MEMORANDUM

DATE: August 18, 2020

SUBJECT: Engineering Geologic Review of Timber Harvesting Plan 1-20-00084 SON

Date: Aug. 2020	Site-Specific Geologic Map To Accompany Engineering Geologic Review of THP 1-20-00084 SON	Figure: 3
Approved By:		
CGS

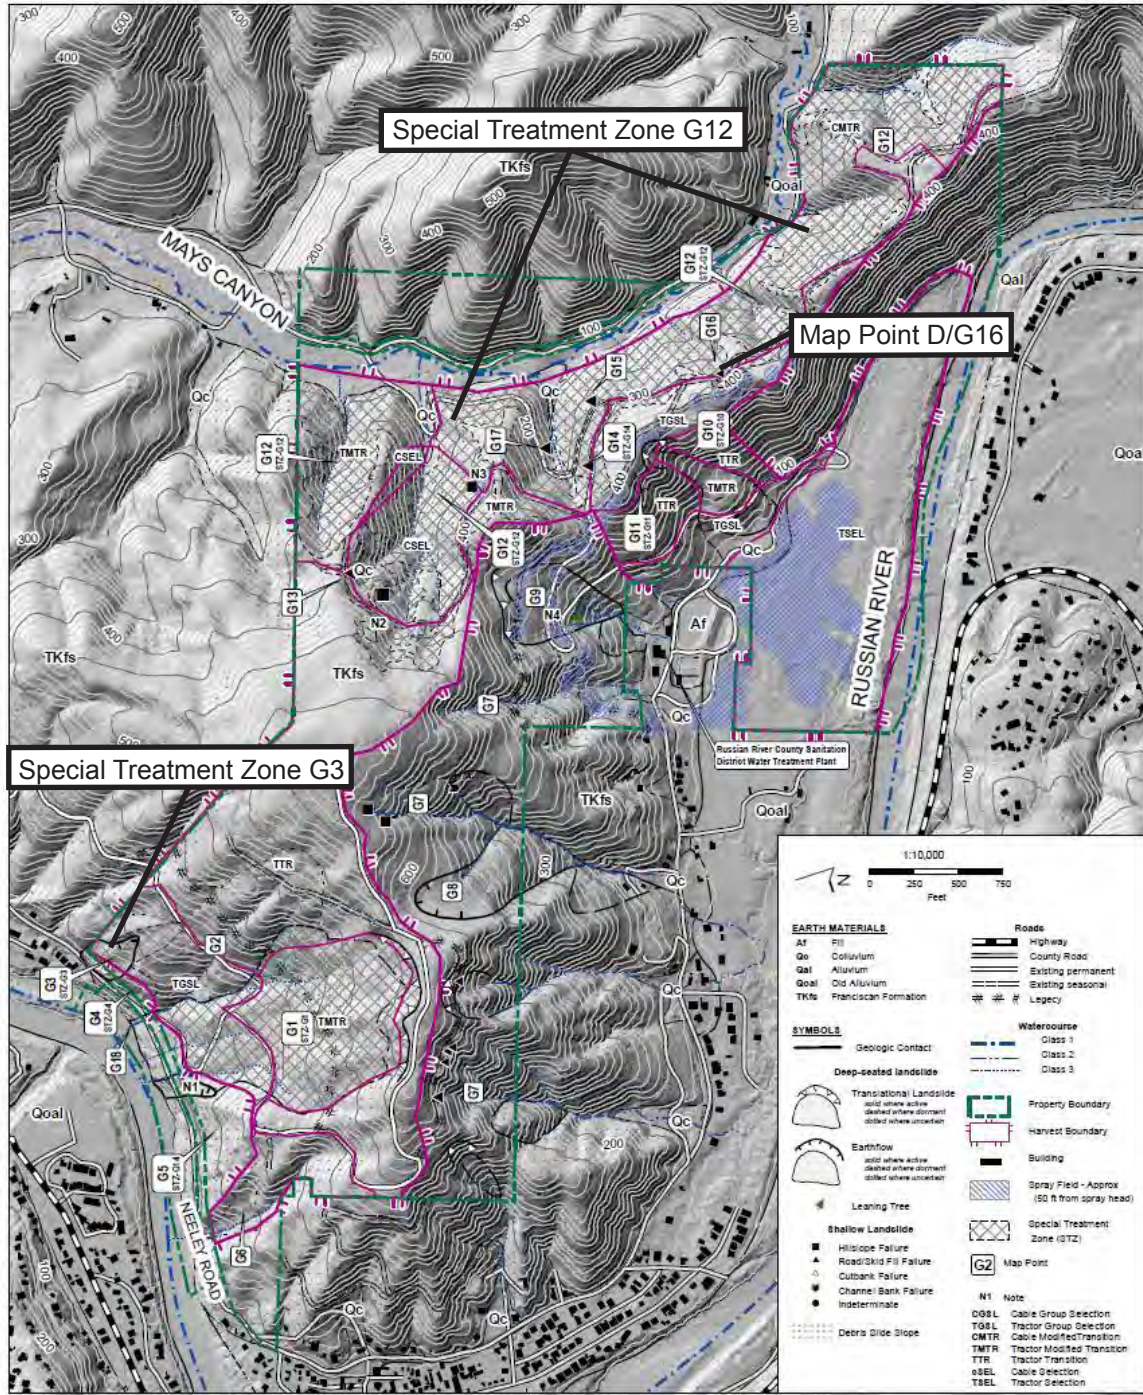
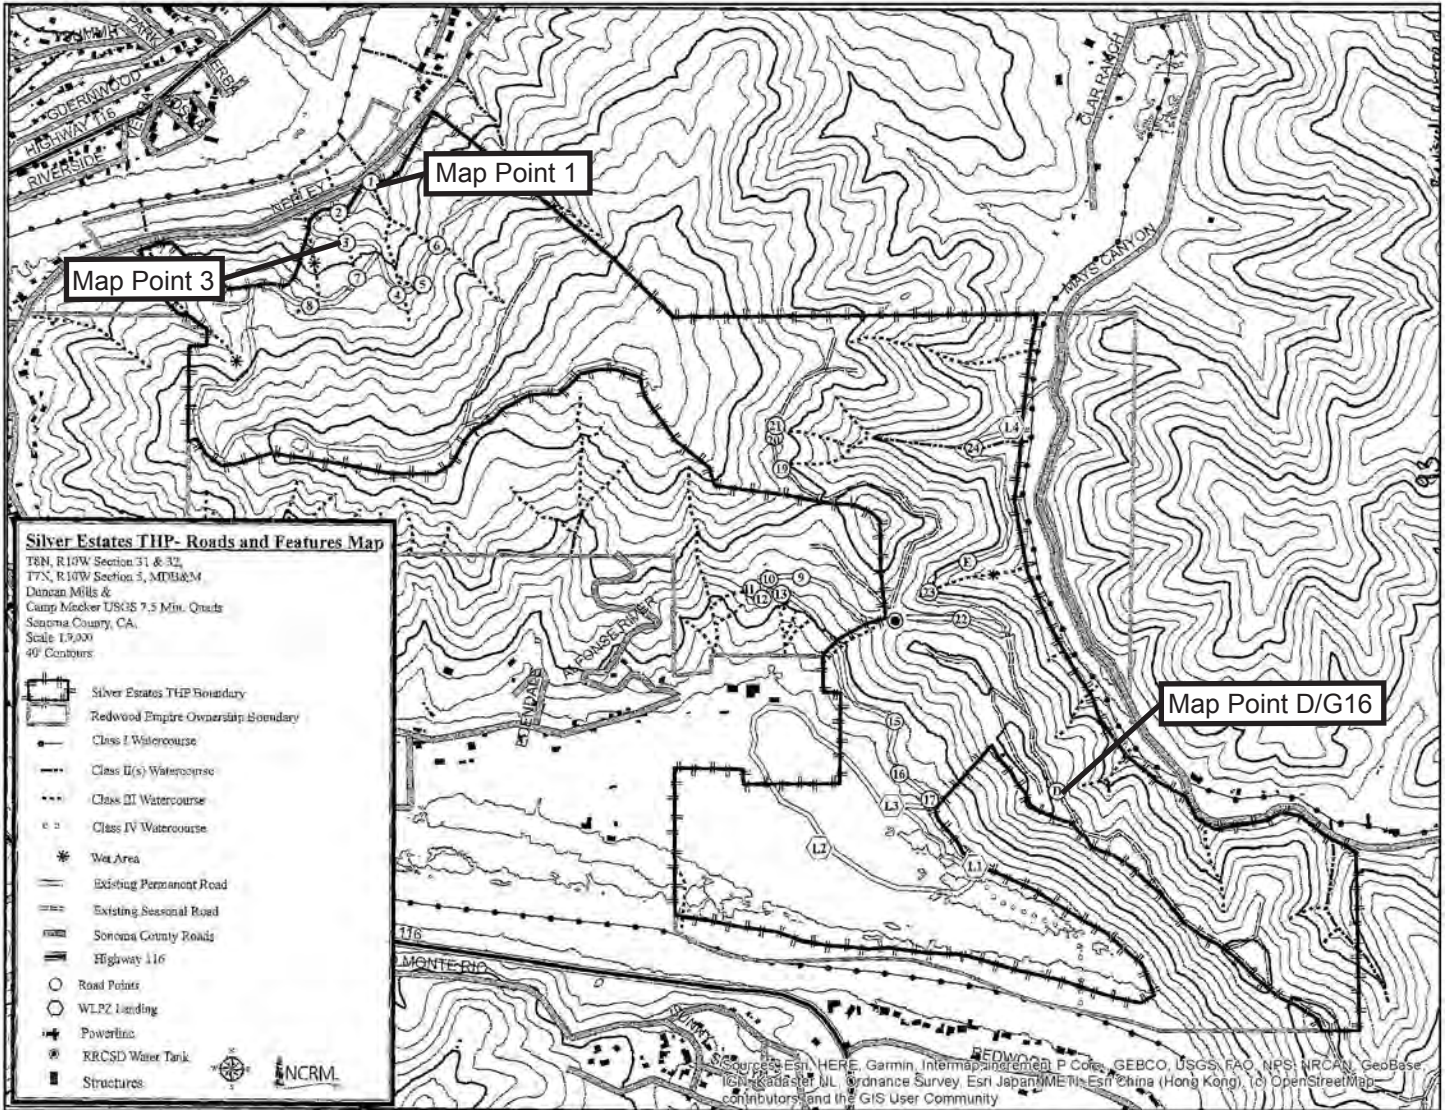
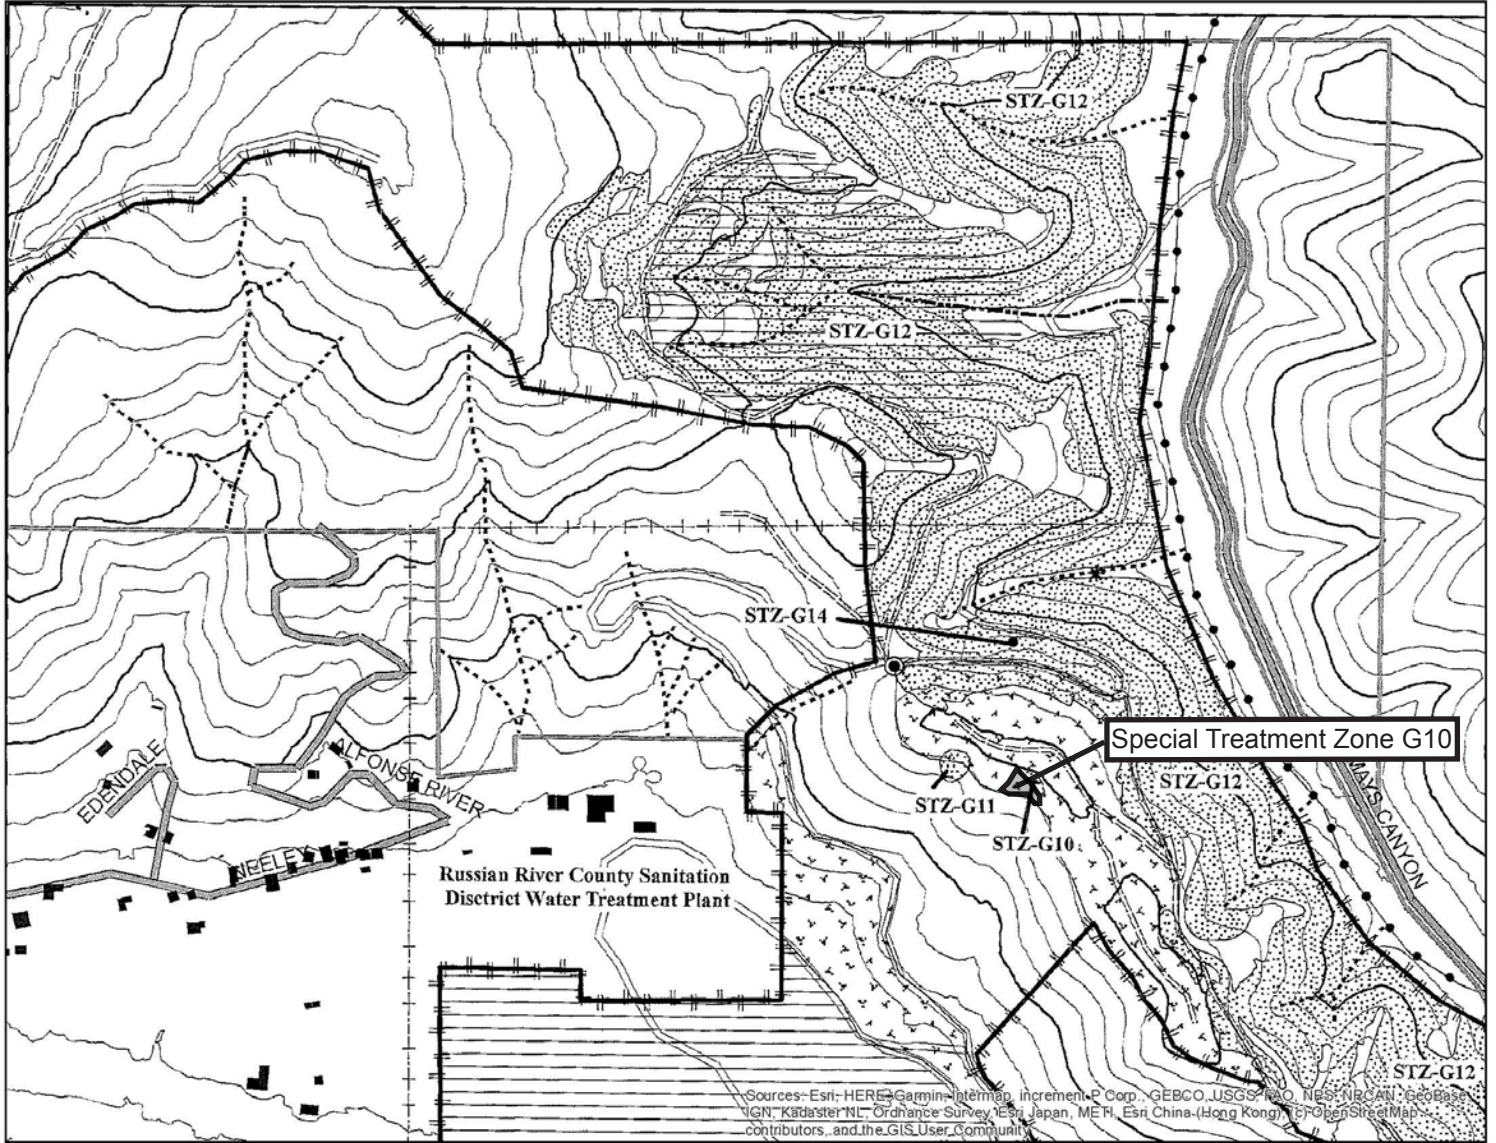
Map Point 3: The THP proposes to install an 18-inch diameter culvert where an existing seasonal road crosses a Class III watercourse at Map Point 3. The seasonal road switches back along the slope and crosses the watercourse at two additional locations (Map Points 2 and 7). Based on review of flow calculations included in Section V of the THP, it appears that the calculated flow at Map Point 7 is larger than the calculated flow at Map Point 3. Map Point 7 is located upstream of Map Point 3. Typically, a watercourse crossing located downstream of another crossing experience a higher flow due to an increase in drainage area and slope runoff, and accumulation of ground water. This suggests that either the flow at Map Point 7 is overestimated or the flow at Map Point 3 is underestimated. During the PHI, the RPF stated that he suspected that the acreages used in the calculations were incorrect. After the PHI, the RPF provided revised calculations using recalculated acreages which appear more representative of the observed watersheds upslope of the crossings. As a result, the RPF proposes to increase the culvert at Map Point 3 from 18-inch diameter to 24-inch diameter.

Special Treatment Zone G10: The plan-attached geologic report (Best, 2020) identifies an approximately 4-acre deep-seated landslide as underlying the southwestern THP boundary. The unstable feature toes into the Russian River floodplain approximately 800 to 900-feet from the active channel and is characterized a rounded scarp above a 40 to 70-percent benched failure slope that supports generally straight-standing second growth conifers. The slide is located within an area proposed for transition and group selection harvesting. The uppermost approximately 0.1 to 0.2-acre of the head scarp of the slide, where group selection harvesting is proposed along 60 to 70-percent slopes, is located within a Russian River Sanitation District effluent spray field. Best (2020) recommends establishing a special treatment zone around the spray area and restricting harvesting operations. During the PHI, it was noted that the silviculture break between transition and group selection harvesting was observed flagged approximately 30 to 50-feet downslope of the STZ. Concern was raised, that a harvesting or the placement of a group opening just downslope of the spray field may result in adverse impacts to slope stability. Extending the no harvest STZ downslope to the silviculture break will minimize the potential for adverse impacts to slope stability by retaining the existing canopy and root function.

Map Point D (Best, G16): The plan-attached geologic report (Best, 2020) describes an approximately 20-foot wide cut bank failure (labeled G16 by Best) along an existing seasonal road proposed for reuse. The road crosses approximately 50 to 70-percent slopes approximately 100 to 150-feet upslope of the head of a mapped Class III tributary to Mays Canyon, a Class I watercourse. Consistent with recommendations by Best (2020), the road was reopened by grading through the deposited material and feathering out the material to either side. During the PHI, unconsolidated earth

materials containing ground cracks was observed sidecast onto the steep slopes. Concern was raised that the unconsolidated material would mobilize during heavy rains and deliver to the Class III watercourse downslope. It was discussed that removing the sidecast material would minimize the potential for adverse impacts to slope stability and sediment delivery.

Map Point 1 (Best, G18): The intersection of an existing seasonal road and a Sonoma County maintained permanent road (Neeley Road) crosses a mapped Class II watercourse along the northwestern THP boundary via an approximately 100-foot long existing culvert. The culvert inlet is located below the upstream edge of the existing seasonal road within the northern THP boundary. According to discussions within the RPF and review of the plan-attached geologic report (Best, 2020), the culvert at the inlet is 24-inches in diameter. This was difficult to confirm, as the culvert was observed to be buried during the PHI. An approximately 6 to 8-foot deep basin was observed at the inlet, which likely allows low flows to pool and seep through to the buried inlet. The outlet of the culvert is located below the downstream edge of Neeley Road approximately 40 to 50-feet upstream of the confluence with the Russian River, a Class I watercourse. The outlet was observed rusted through and shotgunned approximately 4 to 5-feet above the outer road fill prism. An approximately 2-foot wide and deep gully was observed in the outer road fill prism below the outlet. Rock was observed in the gully below the shotgunned outlet that appeared to be minimizing erosion. During the PHI, the culvert at the outlet was observed to be approximately 12-inches in diameter, suggesting that the crossing consists of two culvert segments that are not the same diameter. The watercourse was dry during the PHI, but the observed condition of the culvert and an approximately 2-foot wide and long gully observed in the outer road fill prism below the outlet suggests that water likely pipes through the road fill.

Based on flow calculations included in the plan-attached geologic report (Best, 2020), the 24-inch diameter culvert at the inlet is significantly undersized to accommodate the 100-year flood flow and debris. An approximately 1 to 2-foot wide and deep rill observed along the seasonal road above the inlet suggests that the plugged culvert regularly overtops. The rill extends approximately 40-feet downslope to Neeley Road. An approximately 1-foot wide and deep gully in the outer Neeley Road fill prism across from the rill appears to indicate that the runoff is directed across the road running surface. Accumulated eroded material and rocky bed load observed along both sides of the Neeley Road running surface, suggests that material is deposited on the Neeley Road running surface, likely necessitating cleanup by Sonoma County road crews.

As was stated during the PHI, because Neeley Road is the only access route for residences in the Vacation Beach and Edendale communities, CGS considers the potential for adverse impacts to Neely road a hazard to public safety. Adverse impacts to Neely Road could block emergency access to existing residences and could disrupt utilities located along Neely Road.

The THP proposes to reestablish the capacity of the existing culvert by digging out and rock armoring the culvert inlet. The THP proposes to place a trash rack upstream of the inlet to minimize the amount of rocky material and debris that reaches Neeley Road. The rilled seasonal road running surface will be rocked to minimize continued erosion. During the PHI, it was discussed that maintaining the undersized, mismatched and failing culverts would result in continued overtopping of the watercourse onto Neeley Road during high flows, erosion of the road fill prism resulting from flow piping through the road fill and sediment delivery to the Russian River. The undersized and failing segment of culvert under Neeley Road is located outside of the proposed THP area and according to the RPF outside of the jurisdiction of the THP landowner. Although the THP landowner is amenable to upgrading the segment of culvert under the seasonal road to accommodate the 100-year flood flow and debris, it appears that maintaining the mismatched and failing downstream section of culvert would result in the potential for the culvert to continue to plug, overtop onto Neeley Road and flow to pipe through the Neeley Road fill prism.

The THP states that Sonoma County was contacted and has no immediate plans to replace the culvert. No documentation of the conversation between Sonoma County and Redwood Empire Sawmills is provided in the THP. It was discussed during the PHI, that the RPF and landowner should work with the County to mitigate the failed crossing and public safety hazard. To persuade Sonoma County to work with the landowner and prioritize replacement of the crossing, a copy of this PHI memo describing the existing conditions at Map Point 1 will be forwarded to Sonoma County staff. If not mitigated, future impacts to Neely Road should be anticipated.

Special Treatment Zone G3: The plan-attached geologic report (Best, 2020) maps an approximately 1.5-acre historically-active deep-seated translational landslide within the northern THP boundary. The unstable feature appears to toe into the Russian River and is characterized by 8 to 15-foot high near vertical scarps above a benched failure slope that supports mostly straight-standing and few leaning or pistol-butted second growth conifers. Neeley Road, which is a public access road for the Vacation Beach and Edendale residential communities, crosses the toe of the slide approximately 75 to 100-feet upslope of the Russian River. During the PHI, an existing residential structure was observed along Neeley Road downslope of the northern corner of the THP boundary. Based on mapping by Best (2020) and review of available lidar imagery (2014), it appears that the residential structure is located just above and outside of the northeastern lateral scarp of Slide G3. Best (2020) recommends establishing a special treatment zone (STZ) around Slide G3 from the THP boundary extending upslope of the mapped slide. The THP boundary was observed flagged approximately 75 to 100-feet upslope of Neeley Road. Harvesting within the STZ is to be limited to ground-based single-tree selection with a minimum retention of 100-square feet of total basal area and no group openings. During the PHI, the THP boundary was observed flagged across Slide G3 just downslope of the distinct 8 to 15-foot high head scarp of G3. It appeared that only a few conifers were observed marked for harvest downslope of the scarp. In an effort to

minimize potential adverse impacts to slope stability within the unstable feature and public safety along Neeley Road resulting from the operation of ground-based heavy equipment within the historically-active unstable feature, it was discussed that the marked conifers downslope of the scarp be unmarked and the THP boundary be moved to the top of the head scarp. The RPF agreed and the RPF relocated the THP boundary flagging during the PHI to the top of the head scarp approximately 150 to 200-feet upslope of Neeley Road.

Map Point 3: Prior to second review, Section II of the THP shall be revised to describe that a minimum 24-inch diameter culvert will be installed at Map Point 3. The revised flow calculations shall be included in Section V of the THP.

Special Treatment Zone G10: Prior to second review, Section II of the THP shall be revised to describe that the special treatment zone (STZ) shall extend downslope to the flagged silviculture break. The extended STZ shall be identified on the THP maps.

Map Point D: Prior to second review, Section II of the THP shall be revised to describe that the perched and cracked fill will be pulled back and incorporated into the existing road running surface.

Map Point 1: The public safety concerns regarding failure of the crossing shall be described in Section II of the THP and in the plan attached geologic report (Best, 2020). A copy of this memo shall be cc'd to Sonoma County staff. Without additional mitigation it is unclear how the THP minimizes adverse impacts to slope stability and public safety. As discussed during the PHI, the RPF and landowner shall coordinate with Sonoma County to minimize the existing public safety hazard. If the County refuses or is unable to prioritize replacement of the crossing then it should be clearly understood that a potential for adverse impacts to Neely Road continues. Documentation of Sonoma County refusal shall be included in the THP with an acknowledgement by both Sonoma County and Redwood Empire Sawmills that the public safety hazard continues to exist. CGS assumes no liability in the event that Neely Road is impacted by upslope conditions in the future.

Special Treatment Zone G3: Prior to second review, the THP maps shall be revised to accurately show the revised northern THP boundary.
